Sea Link

Volume 9: Examination Submissions

Document 9.123: Applicant's Responses to Second Written Questions

Planning Inspectorate Reference: EN020026

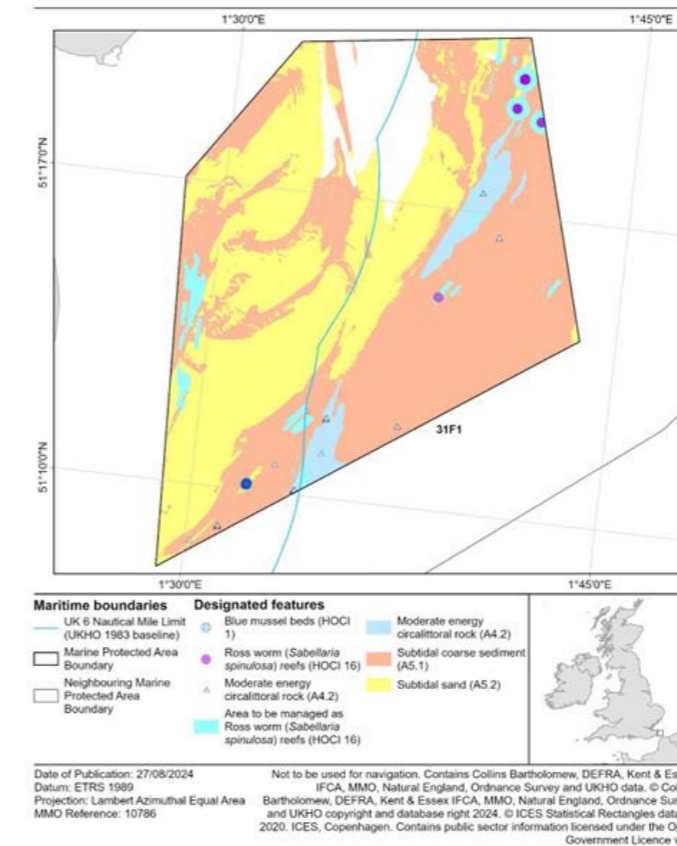
2BE4.	NE	<p>Seabed disturbance – Thanet Coast SAC</p>
